PLANNING COMMISSION MEETING
Monday, August 14, 2023 – 7:00 p.m.
City Council Chambers
23600 Liberty Street
Farmington, MI 48335

LEGION SQUARE - PUBLIC HEARING AND PUD SITE PLAN REVIEW: CERVI CONSTRUCTION, AMERICAN LEGIONAL HALL, 31775 GRAND RIVER AVENUE

RE: Legion Square – PUD Site Plan Review #2
 31775 Grand River Avenue
 Proposed Zoning: PUD – Planned Unit Development

RE: Legion Square – PUD/Site Plan Review #2
31775 Grand River Avenue

Statistics						
Description	Symbol	Avg	Max	Min	Avg/Min	Max/Min
Central Drive and Parking	⊗	1.2 fc	4.2 fc	0.2 fc	6.0:1	21.0:1
Overall Grade	+	0.7 fc	5.9 fc	0.0 fc	N/A	N/A
Property Line	+	0.0 fc	0.2 fc	0.0 fc	N/A	N/A

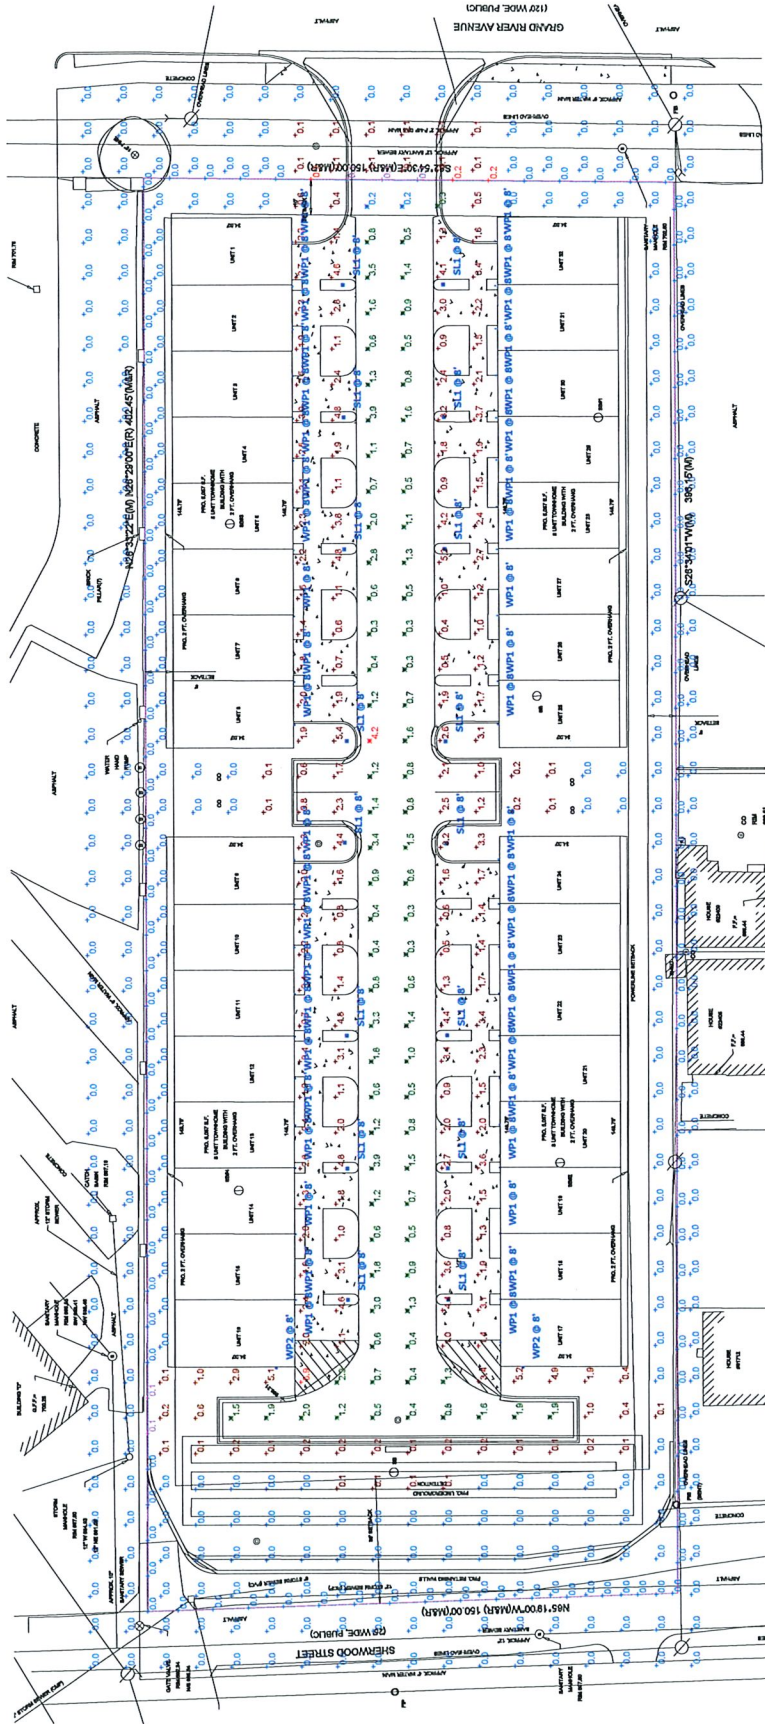
- G. Lighting – The lighting package has been modified so that there are now 16 pole mounted fixtures adjacent to the central road, with all fixtures being mounted at 8 feet. The photometric levels remain at or near 0 along all property lines as required by the ordinance.

- ~~8. The pole height need to be denoted on the plans.~~

FRONT ELEVATION - 8 UNIT BUILDING
SCALE: 3/16" = 1'-0"

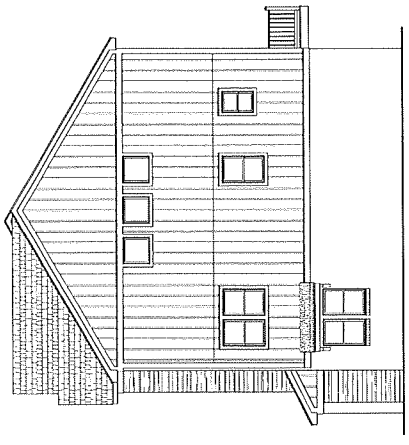
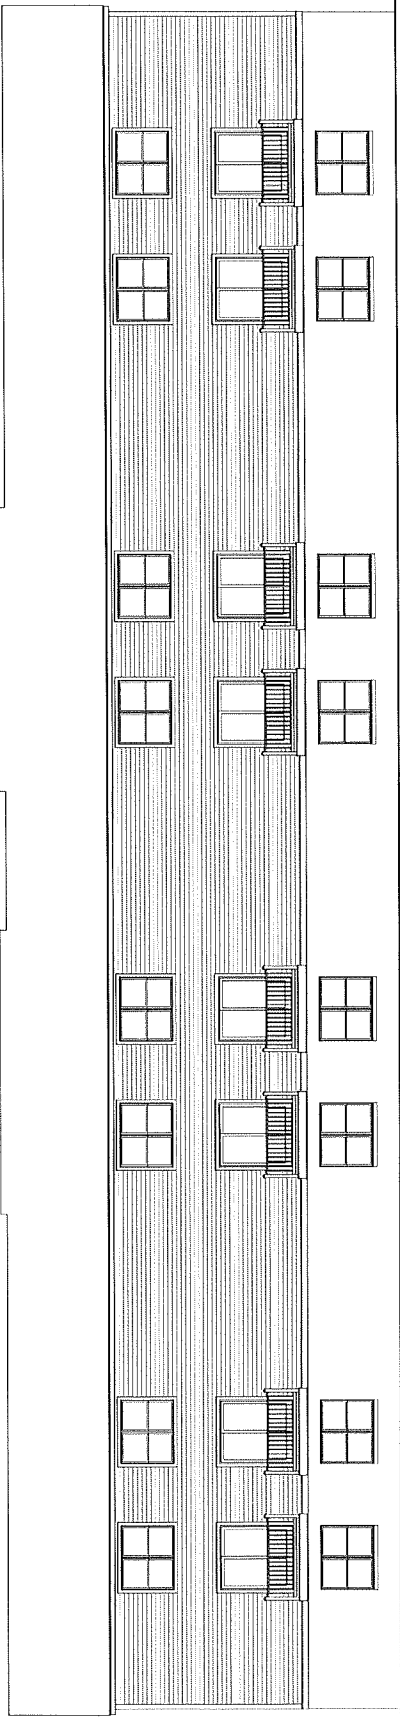
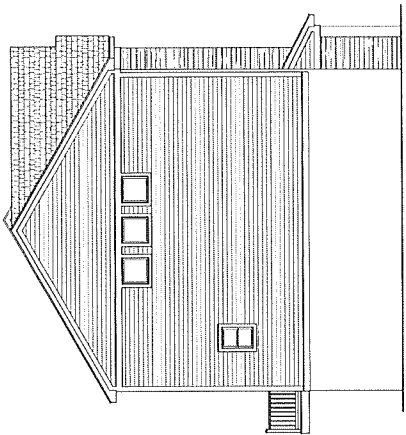
1. Provide detailed and colored renderings for all 4 building facades (not just the interior façade) to ensure compliance with the noted intention to provide enhanced quality of the architecture. Additionally, the materials reflected in the colored renderings need to match those of the black and white elevations.
- ~~2. Mitigation of offsite impacts are being addressed through on-site stormwater retention via an underground storm detention system (defer to the Engineering review) and impacts on the abutting residential development are limited due to the proposed dead-end street.~~

Comments related to facades that face Grand River Ave. The most recent letter from OHM had requested the facades be changed to look less like a side elevation. In response to this we had a conference call with Jennifer at OHM. She ask to have it drawn to look more like the front facades. This recommendation has been sent to the project architect to make this change. Unfortunately, we will not have it by the submittal deadline for the August 14th meeting.

Cervi stated more windows were added and transoms up above, a board and batten style siding as well as Hardee siding. He stated the trim will be white, the overhangs and the trim and the soffits and the siding will be darker blue for the siding with red brick below. And the back side is lap siding, with brick on the first floor.
